Bottle Rock Power Steam Project

Response to Comments Final Environmental Impact Report / Environmental Assessment

State Clearinghouse No. 2009102035
December 9, 2010

Exhibit 5.2-5
Existing Intersection Traffic Volumes

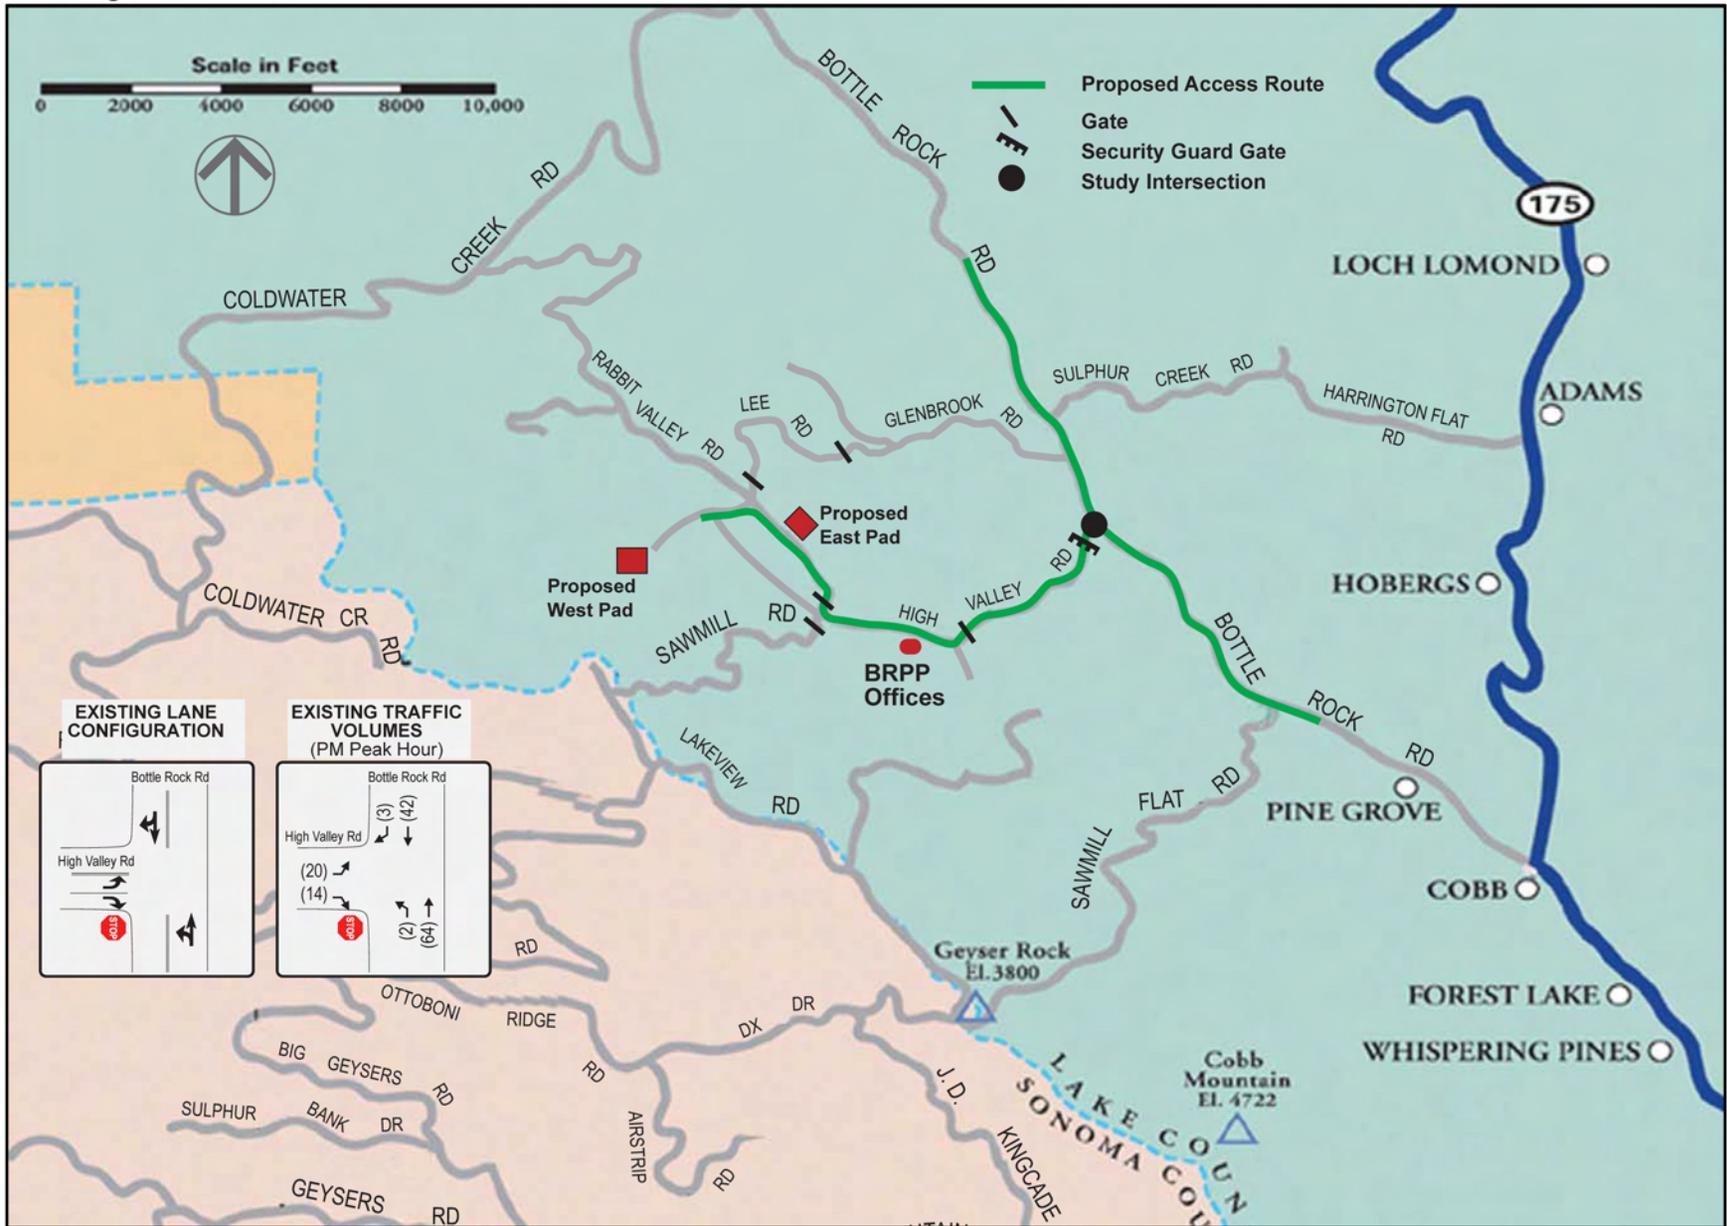
Multiple comments were received during the public comment related to the Coldwater Creek Road alternate access that exhibits in the Draft EIR/EA that depict the existing road network are incorrect. The commentors are correct; Rabbit Valley Road does connect to Coldwater Creek.

Accordingly, **Exhibits 5.2-1, 5.2-5, 5.2-13, 5.2-16, 6.0-1, and 6.0-2** have all been revised to illustrate the connection between Rabbit Valley Road and High Valley Road.

Mr. Richard Coel, Director
Department of Community Development
County of Lake
255 Forbes Street.
Lakeport, CA 95453

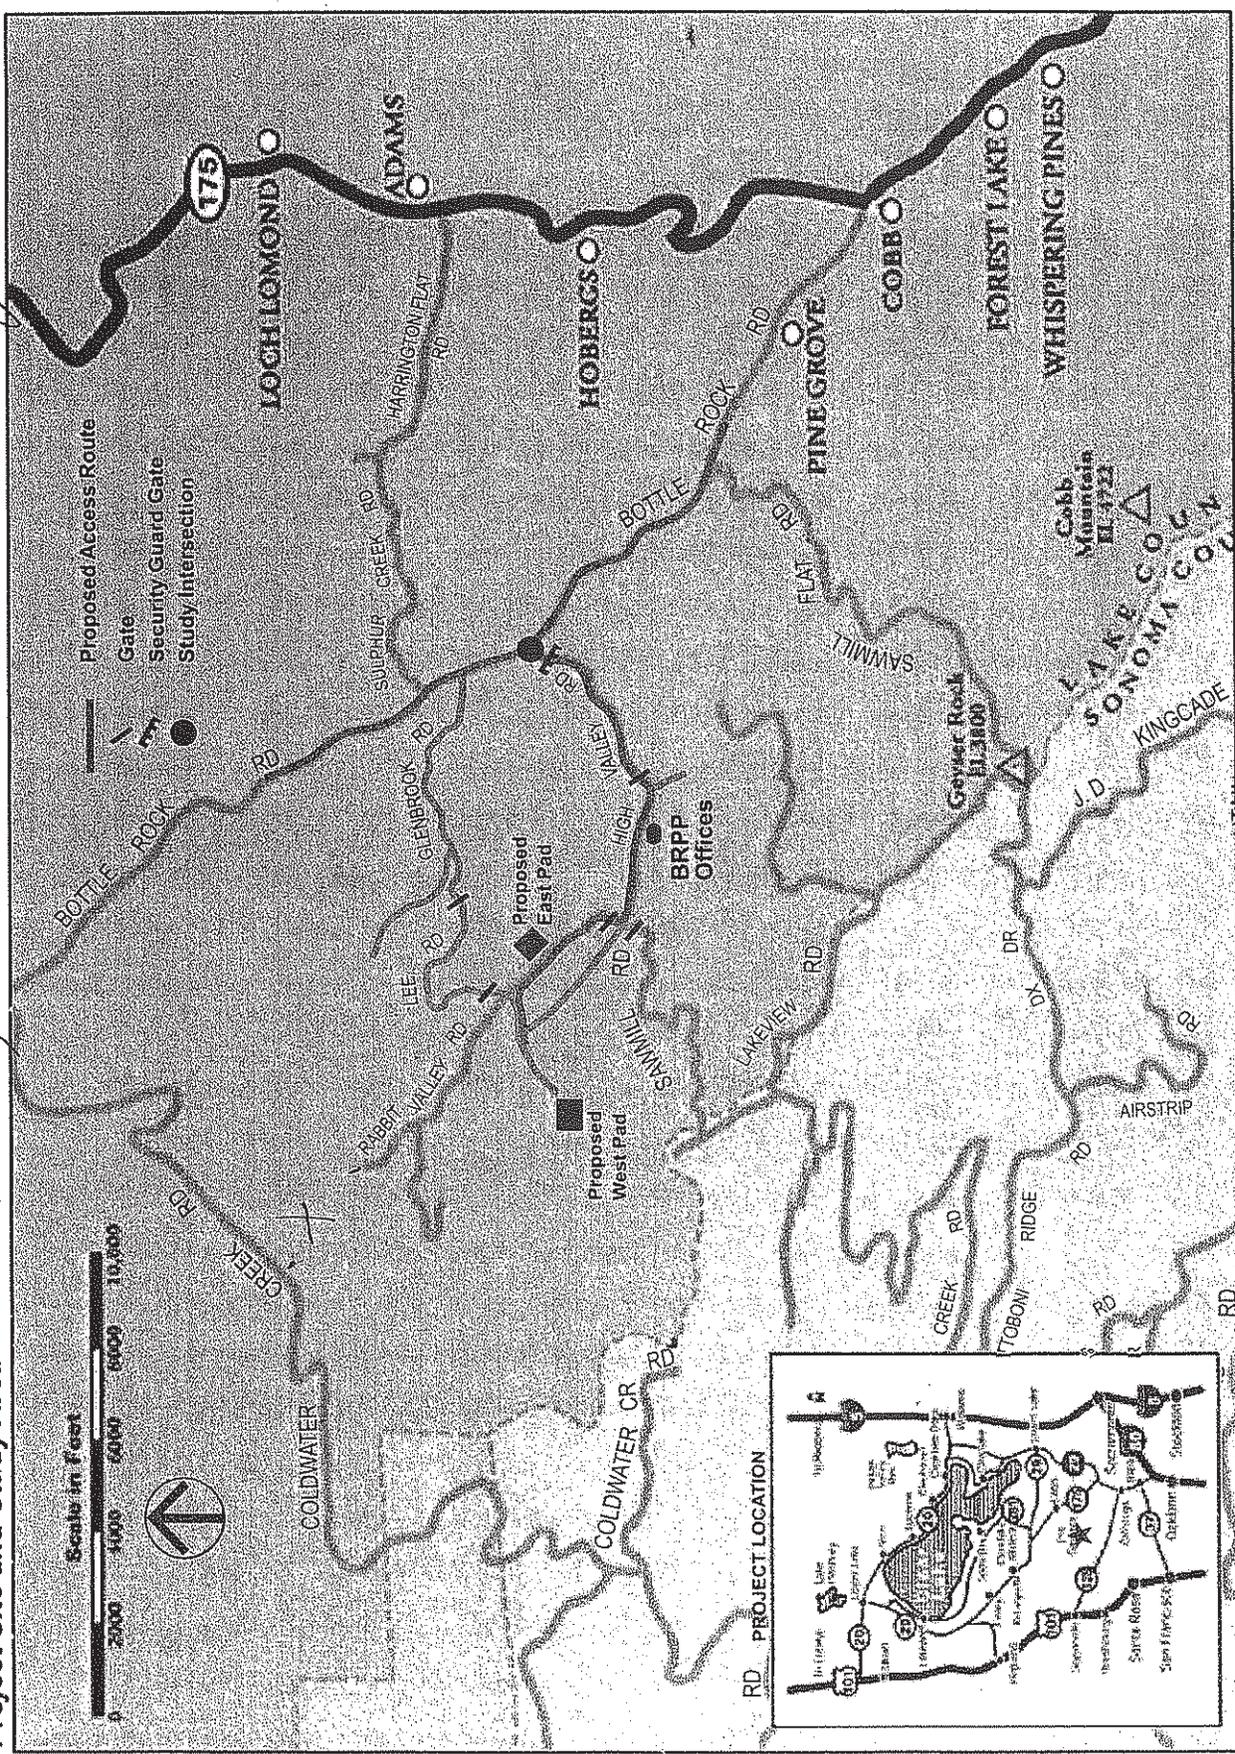
The opinions expressed in the comment are noted and will be considered by the decision-makers in their deliberations on the project.

map figure 1:2:1 is in error as well as many other of the maps. it fails to show Rabbit Valley Road as a continuous paved road intersecting Cold Water Creek Road which then comes back out on Bottle Rock Rd.
